<div style="text-align: center;"> 適航指令發布單 Airworthiness Directive Issuance Form </div>			
民航局AD編號 AD Number	CAA-2015-08-001	發布日期 Date issued	2015/8/10
適用之航空產品 Applied to (models, serial numbers or part numbers, as applicable)	This AD applies to the following helicopters, when equipped with a Goodrich hoist having a Part Number (P/N) as listed in Table 1 of this AD: AW109SP, AB139, AW139, AB412 and AW189 (all Models) helicopters, all serial numbers (s/n); BHTI 212, 214 and 412 helicopters, all Models, all s/n; BHTC 429 and 430 helicopters, all s/n; AH AS 365 N3, AS 332 L2, EC225 LP and EC175 B helicopters, all s/n; AHD MBB-BK117 C-2 and D-2, EC135 and EC635 (all Models) helicopters, all s/n; MDHI MD900 helicopters, all s/n; and Sikorsky S-61 (all Models), S-76A, S-76B, S-76C and S-92A helicopters, all s/n.		
主旨摘要	Equipment / Furnishings – Hoist – Test / Replacement		
<div style="text-align: center;">民航局 CAA</div> <input type="checkbox"/> 本國產品 Native products <input type="checkbox"/> 其他個案 Other	<div style="text-align: center;">設計國民航主關機構 Original Authorities</div> <div style="display: flex; justify-content: space-between;"> <div> <input type="checkbox"/> FAA <input checked="" type="ch

Figure 1

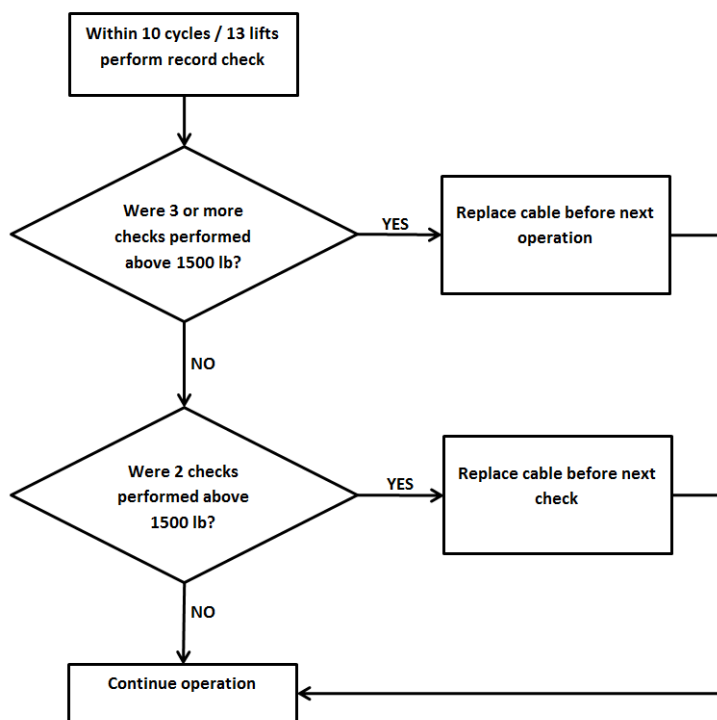
Effective Date:	18 August 2015
Required Action(s) and Compliance Time(s):	<p>Required as indicated, unless accomplished previously:</p> <p>(1) Within 10 hoist operating cycles or 13 hoist lifts (as applicable, see Note 1 of this AD) after the effective date of this AD, determine the P/N of the hoist installed on the helicopter and, if a Goodrich hoist is installed with a P/N listed in Table 1 of this AD, accomplish a records check to determine whether, during any previous hoist load check/test, a cable was load-tested (average of 5 pulls) at 1 500 lb [680 kg] or more. If any cable is identified to have exceeded this limit during three or more hoist load checks/tests, before next hoist operation, replace the affected cable with a serviceable cable. If any cable is identified to have exceeded this limit during two hoist load checks/tests, before the next hoist load check/test, replace the affected cable with a serviceable cable. For replacement of a cable, see figure 1 (flowchart) of this AD.</p>
